VALUE ENGINEERING WORKSHOP

WIDENING US 441 – FARGO TO PEARSON PROJECTS EDS 441 (41, 46, 48, & 49) Clinch & Atkinson Counties, Georgia

VALUE ENGINEERING TEAM STUDY

PROPOSAL NUMBER:	RW-9.0
PAGE NUMBER:	3 of 5

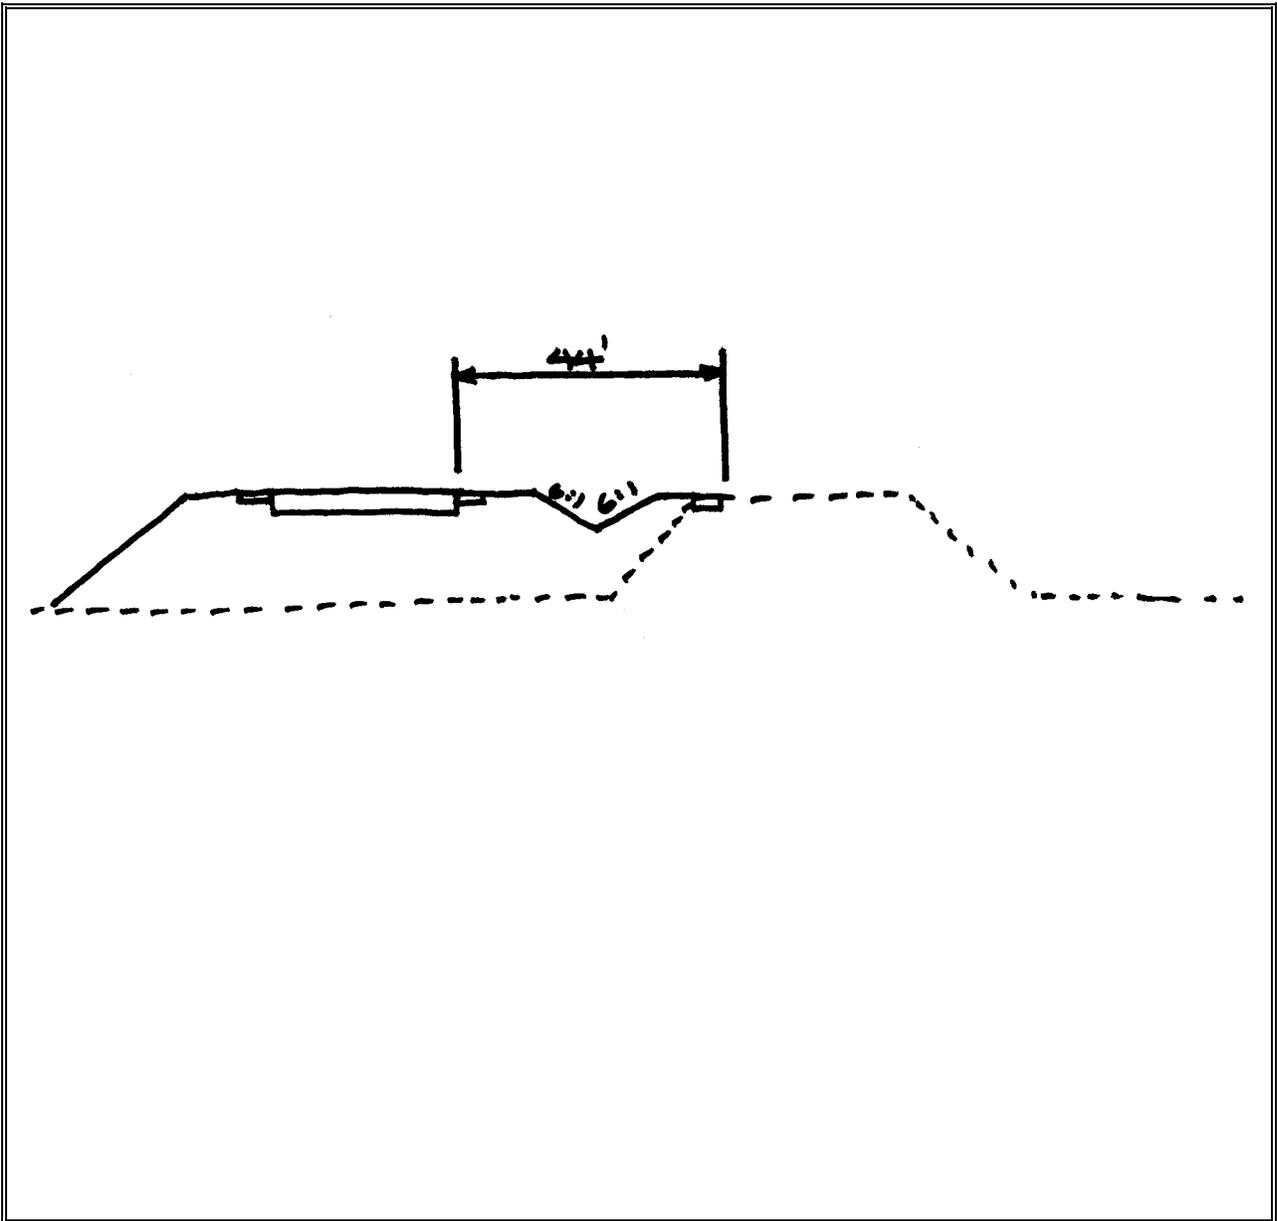
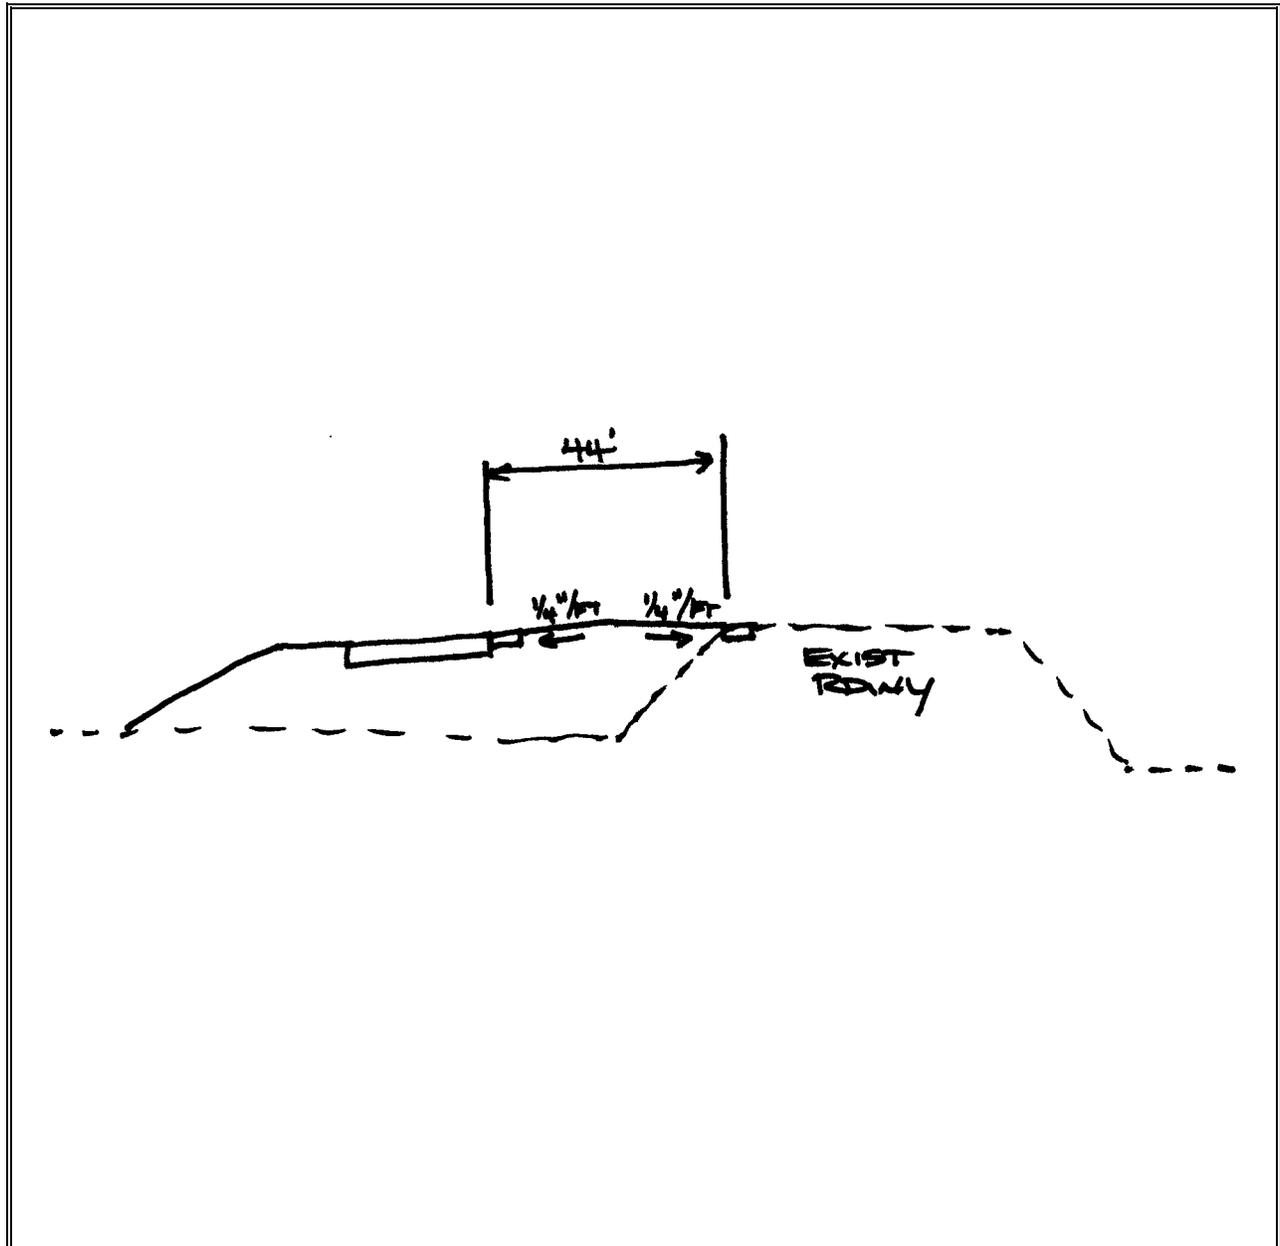
PROPOSED CHANGE: The proposed change recommendation would eliminate the depressed median and change the median to match the crown of the roadway.

The proposed change still allows for the same design speeds, yet saves on construction and maintenance costs.
